# Response to Submissions Documentation

## Waterloo South

Stockland and Homes NSW

Revision B

Deep Soil Provisions & Through-Site Link

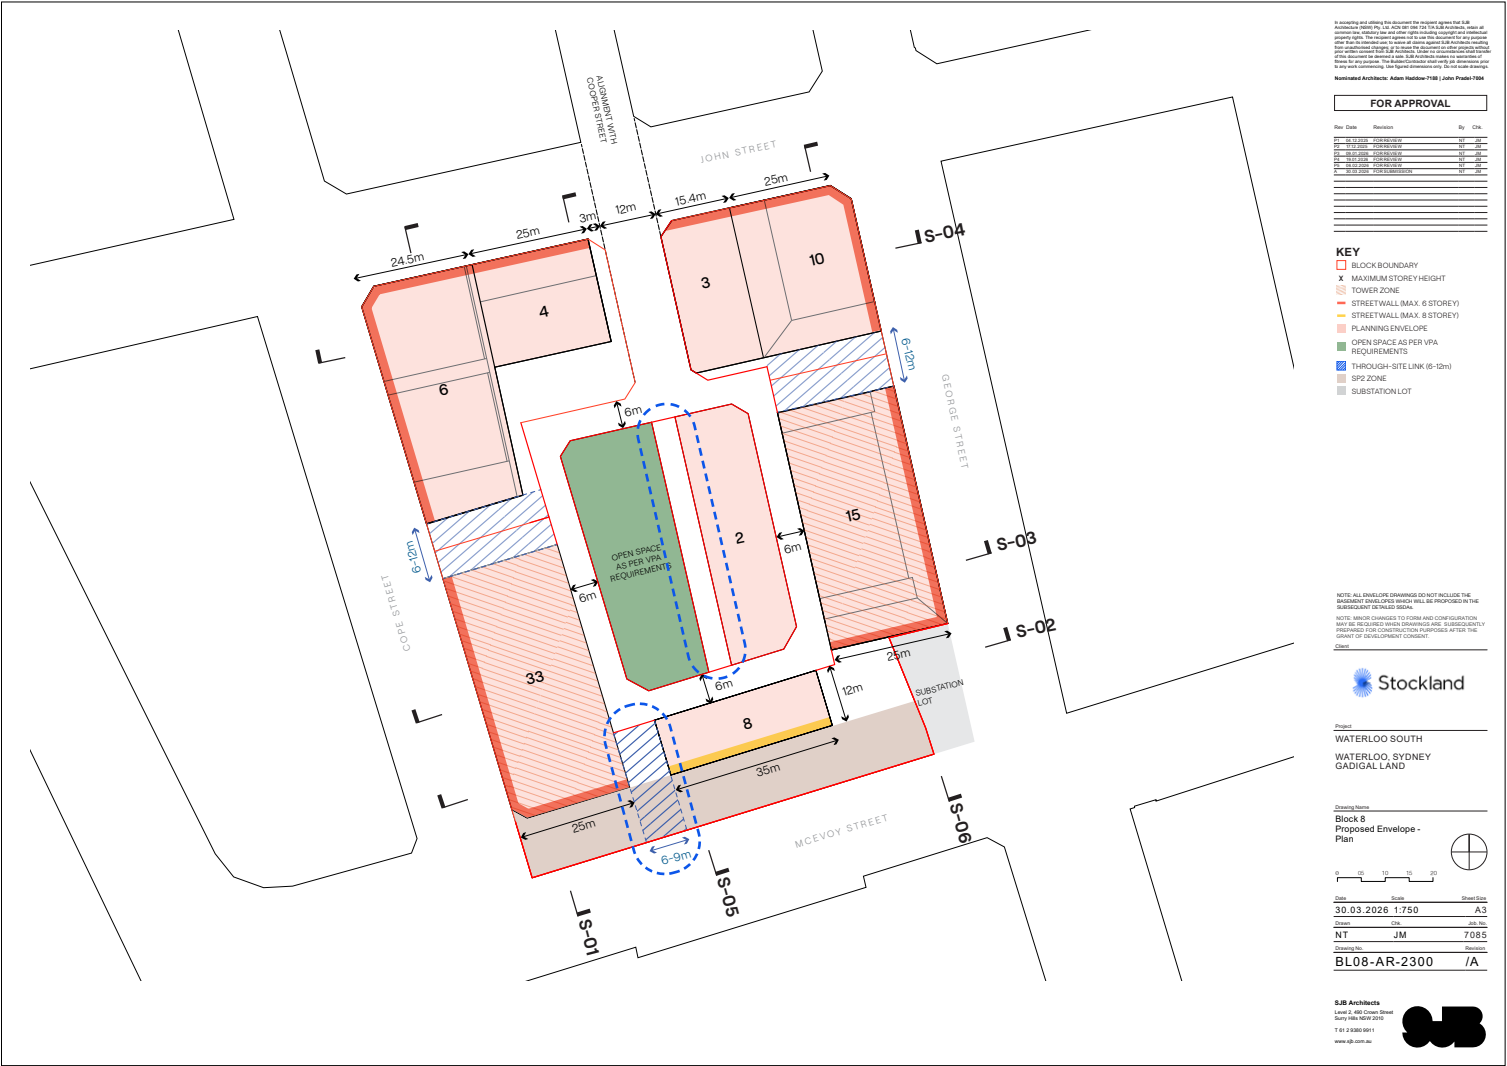
| Agency                                 | Summary of Key Issues                                                                                                                                                                                                                                                                                                                                                                                                                                                                                                                                                                                                                                 | Response                                                                                                                                                                                                                                                                                           | Supporting RtS Documentation |
|----------------------------------------|-------------------------------------------------------------------------------------------------------------------------------------------------------------------------------------------------------------------------------------------------------------------------------------------------------------------------------------------------------------------------------------------------------------------------------------------------------------------------------------------------------------------------------------------------------------------------------------------------------------------------------------------------------|----------------------------------------------------------------------------------------------------------------------------------------------------------------------------------------------------------------------------------------------------------------------------------------------------|------------------------------|
| City of Sydney                         | The concept plans indicate inconsistent provisions of deep soil with the Design Guide. It is recommended that envelope plans remove references to deep soil and future development applications rely solely on deep soil targets provided in the Design Guide. It is also encouraged that the Design Guide incorporate additional requirements for deep soil and on-structure planting design requirements as provided in the Sydney Development Control Plan 2012 (SDCP 2012).                                                                                                                                                                       | <p>SJB to remove deep soil references shown in ‘<i>Appendix C: Envelope Plans</i>’.</p> <p>ASPECT has provided revised deep soil calculations to address inconsistencies.</p>                                                                                                                      | Pg 53 - 56                   |
| DPHI                                   | The proposed envelope plans refers to deep soil planting that is not consistent with the reference scheme or DG. Please remove reference to deep soil zones on the proposed envelope plans to avoid this discrepancy.                                                                                                                                                                                                                                                                                                                                                                                                                                 |                                                                                                                                                                                                                                                                                                    |                              |
| DPHI<br>Stockland                      | <p><u>Through-site links</u></p> <p>The Department understands Homes NSW is redesigning block 8 to reintroduce a southern through-site link to improve permeability and address CPTED concerns. The Department supports this approach and requests the through-site link to be reinstated and reflected consistently across the DG and Concept Plan.</p>                                                                                                                                                                                                                                                                                              | <p>Southern through-site link on Block 8 added to envelope drawings.</p>                                                                                                                                                                                                                           |                              |

The only reference made to Deep Soil within the Concept Plans relates to Block 8 between the Block 8 Park and VPA building in Appendix C - Envelope Plans. References to this will be removed from the Envelope Plans within the Concept SSDA RtS for consistency.

Amend to reflect additional through-site link added between 8AB1 and 8AB2 (6 to 9m).

Proposed RtS Envelope Plan Amendments - diagram summaraising amendments. North-west view.

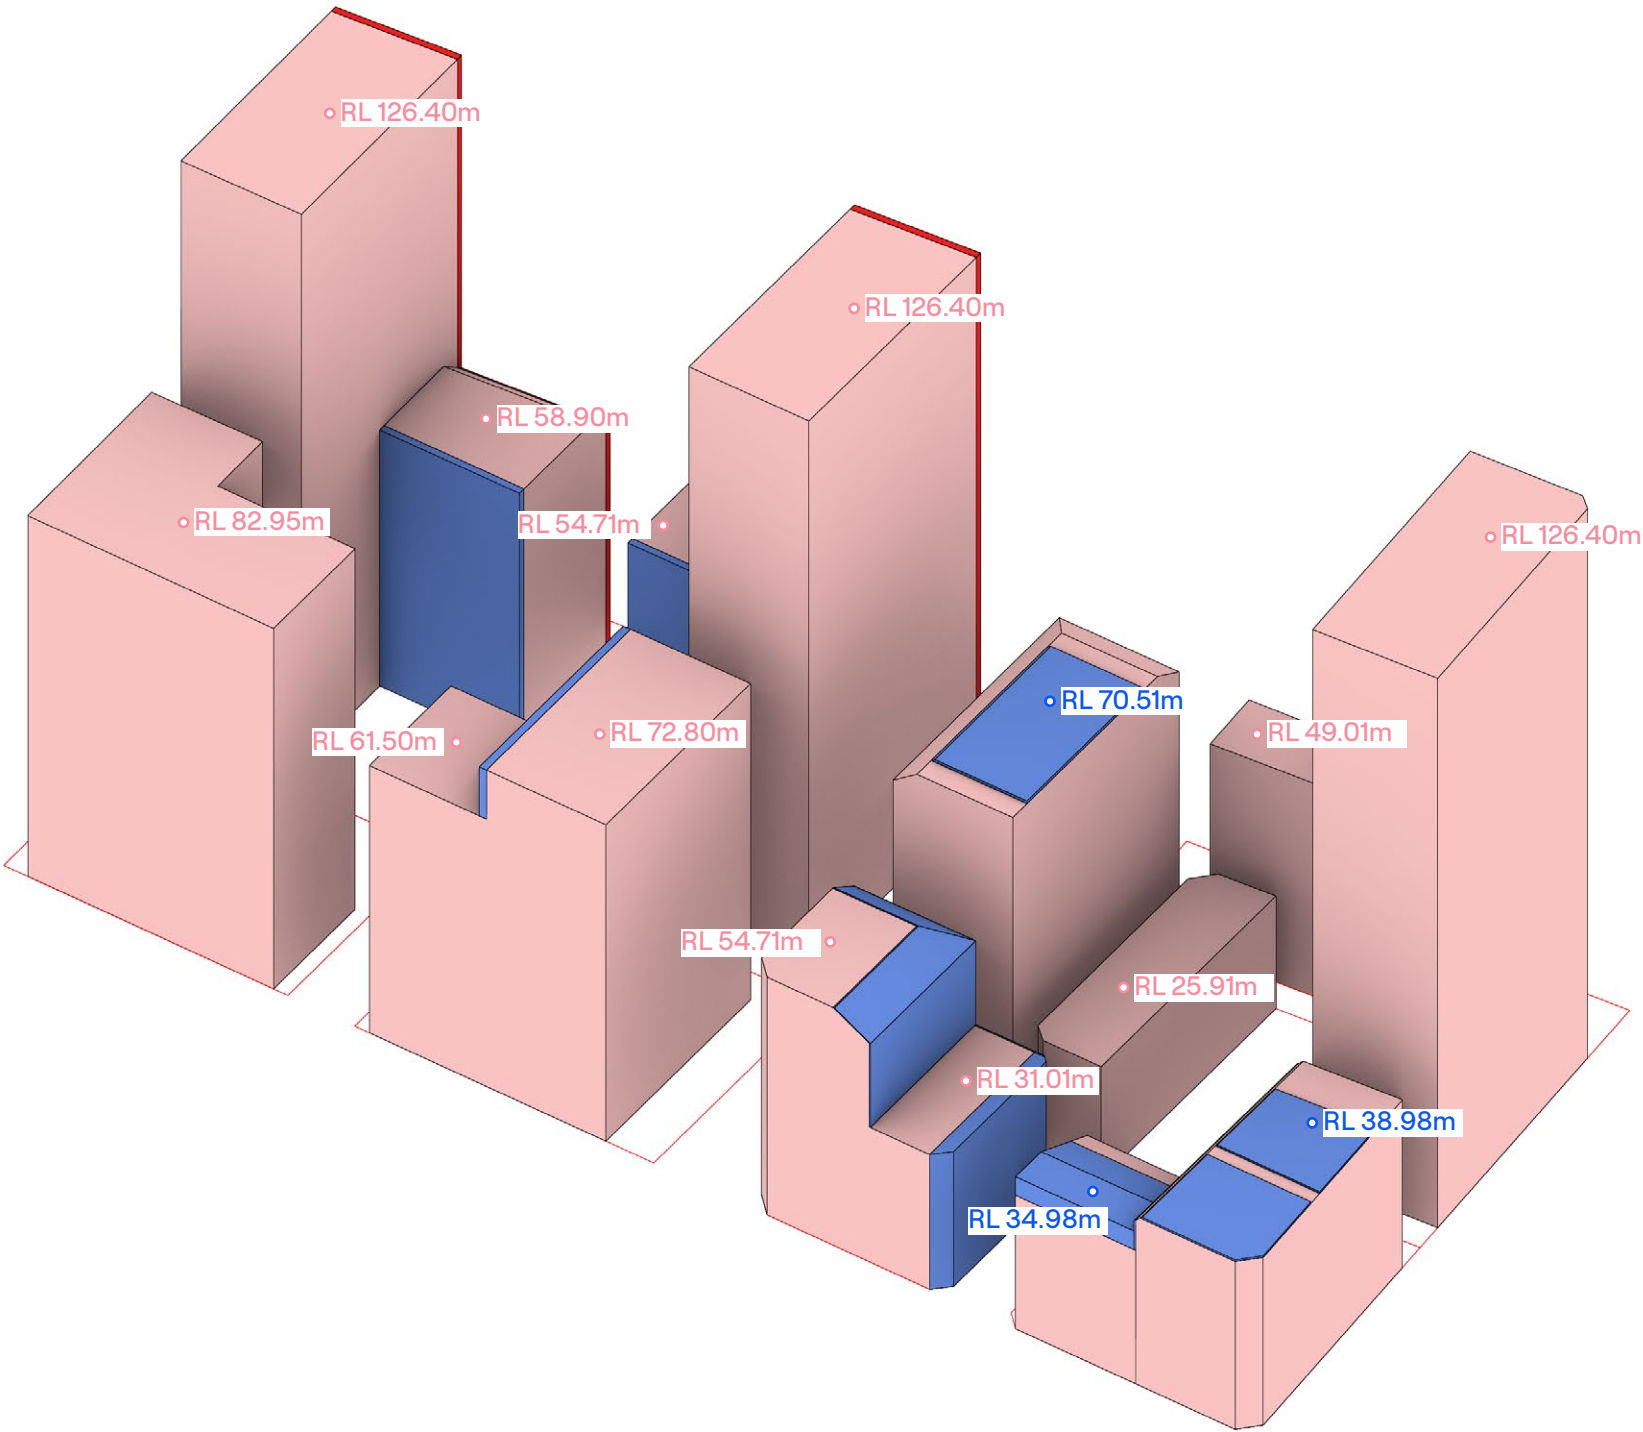
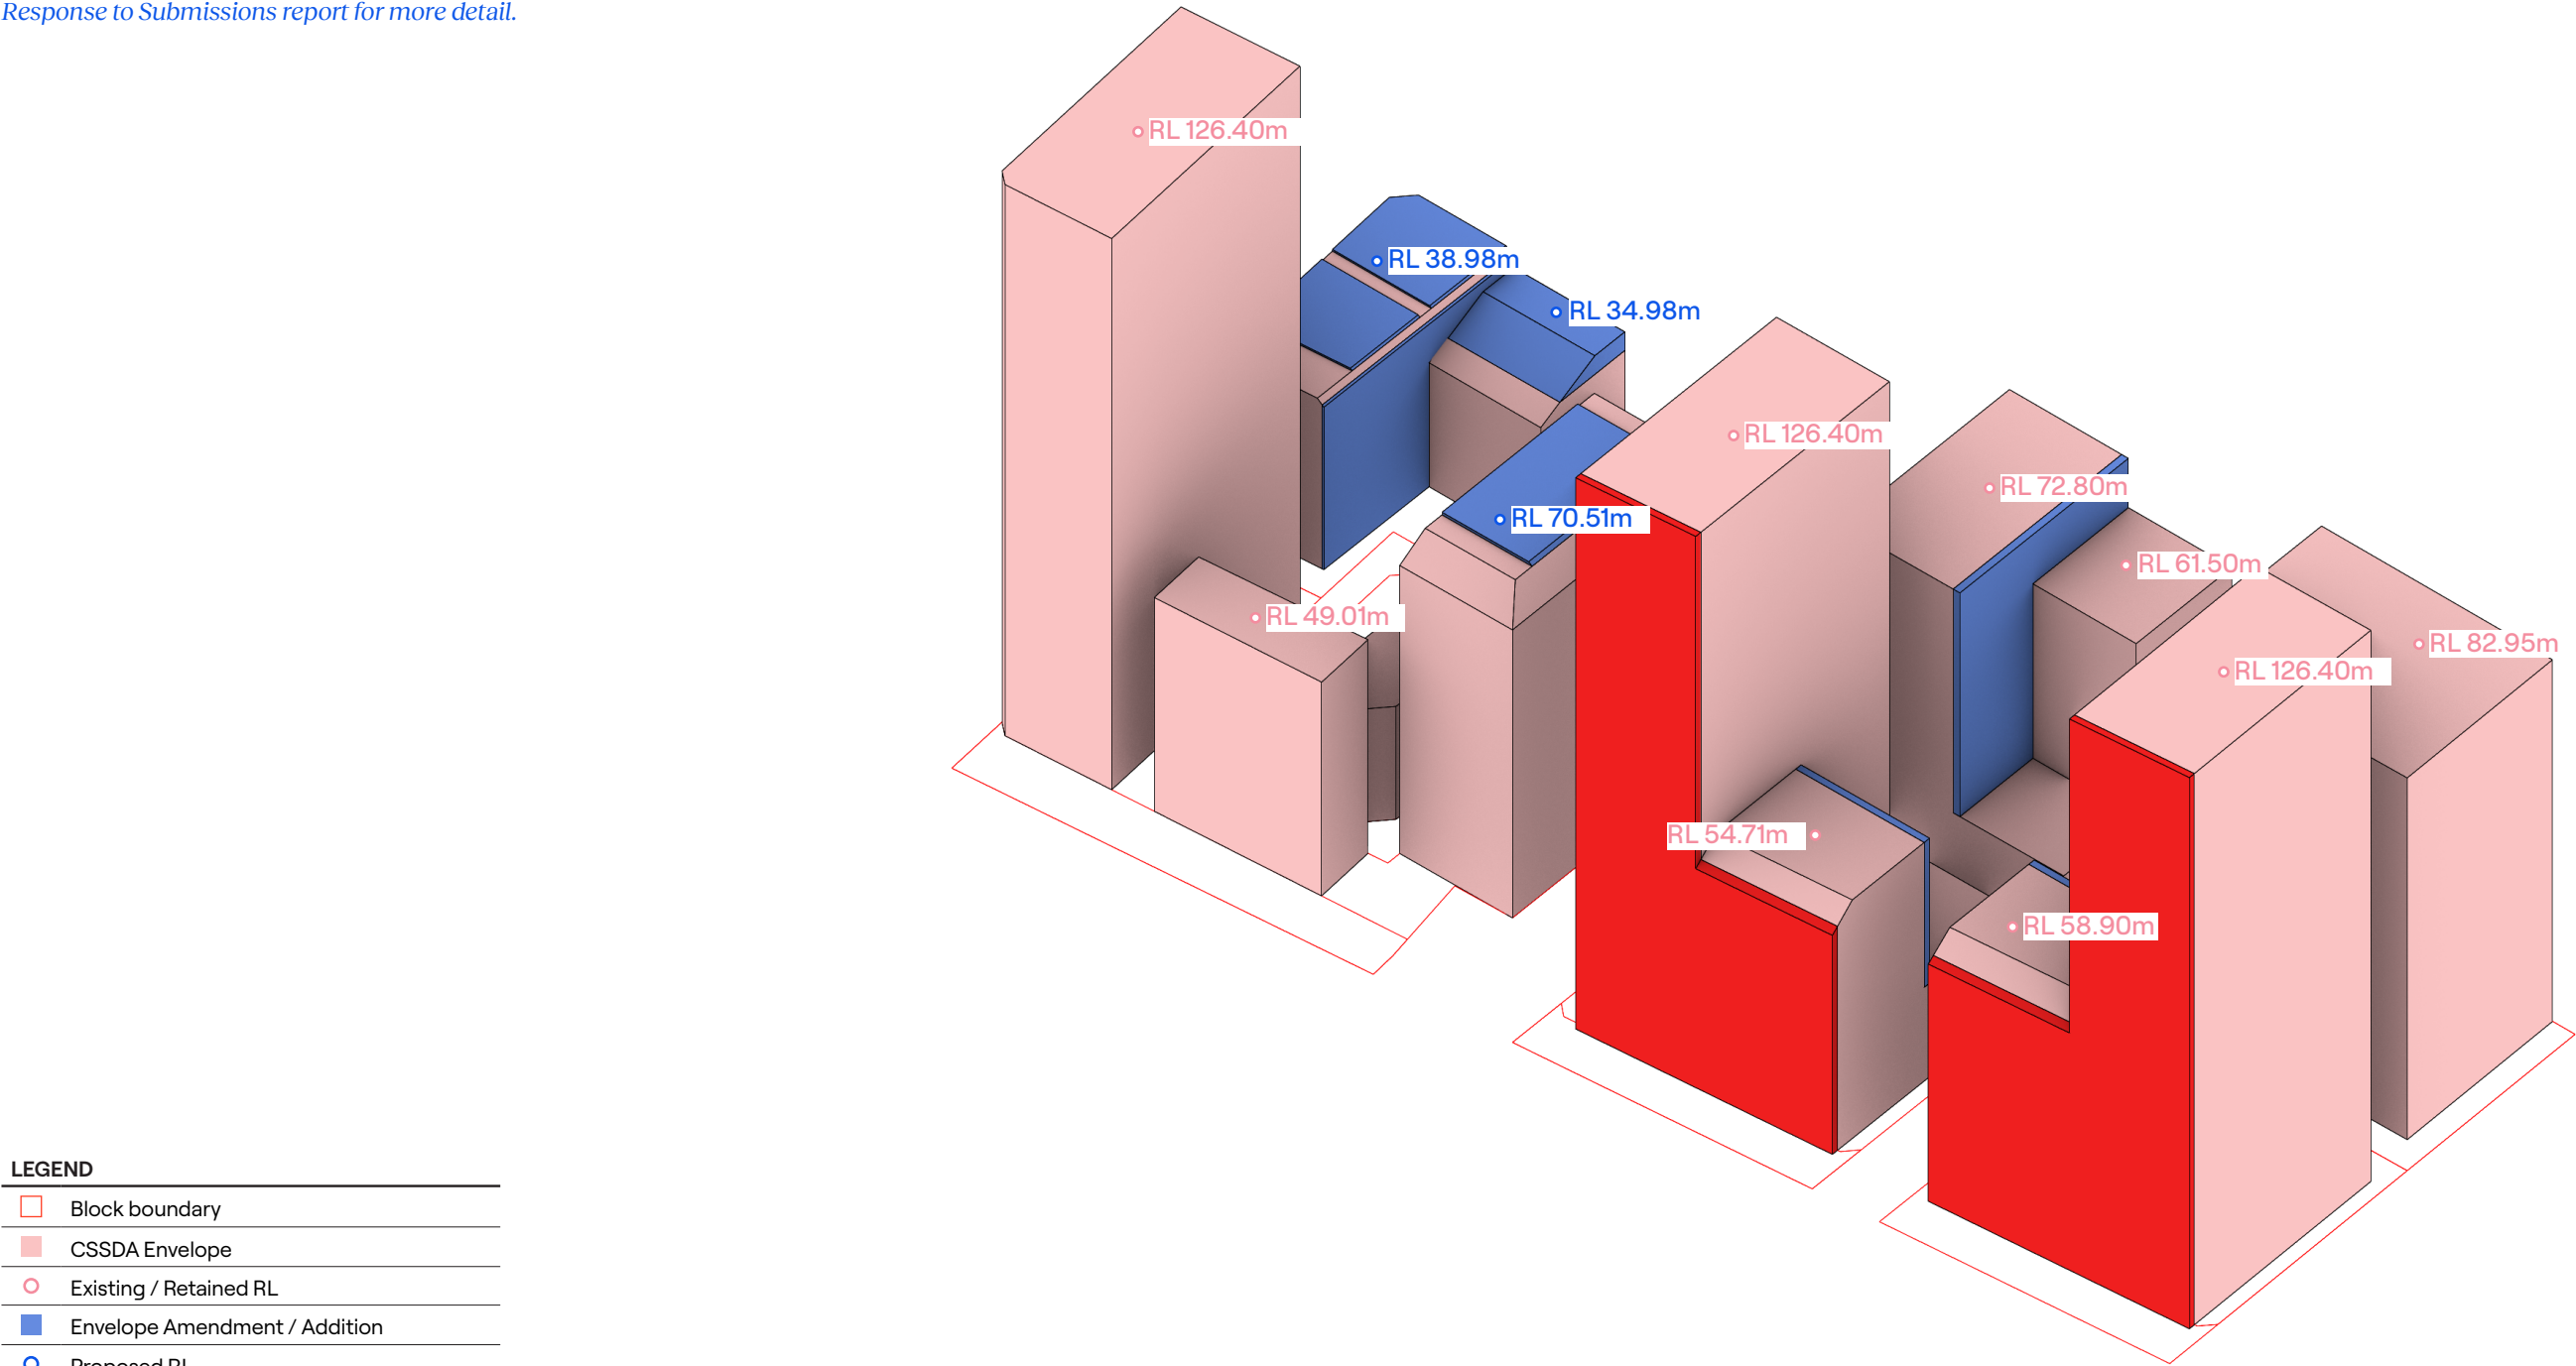
| Agency                                 | Summary of Key Issues                                                                                                                                                                                                                                                                                                                                                                                                                                                                                                                                                                                                                                 | Response                                                                                                                                                                                                                                                                                           | Supporting RtS Documentation |
|----------------------------------------|-------------------------------------------------------------------------------------------------------------------------------------------------------------------------------------------------------------------------------------------------------------------------------------------------------------------------------------------------------------------------------------------------------------------------------------------------------------------------------------------------------------------------------------------------------------------------------------------------------------------------------------------------------|----------------------------------------------------------------------------------------------------------------------------------------------------------------------------------------------------------------------------------------------------------------------------------------------------|------------------------------|
| Stockland<br>Transport for NSW<br>DPHI | Envelope amendments are proposed to align with the concurrent Stage 1 SSDA design, accommodating façade, structural and services encroachments and resolving encroachments into TfNSW land along McEvoy Street.                                                                                                                                                                                                                                                                                                                                                                                                                                       | <p>Minor envelope amendments are proposed for Buildings 8AB3, 8CB1, 8BB1 and 9BB1.</p> <p>Revisions to 9AB1 and 10AB1 respond to encroachment on TfNSW titles along McEvoy Street.</p> <p>Refer to Appendix C for more detail.</p>                                                                 |                              |

Rooftop plant and services accommodated through a 380mm envelope increase; podium envelope extended by 4.28m to incorporate communal rooftop structures.

Envelope increased by 600mm to accommodate rooftop plant and services.
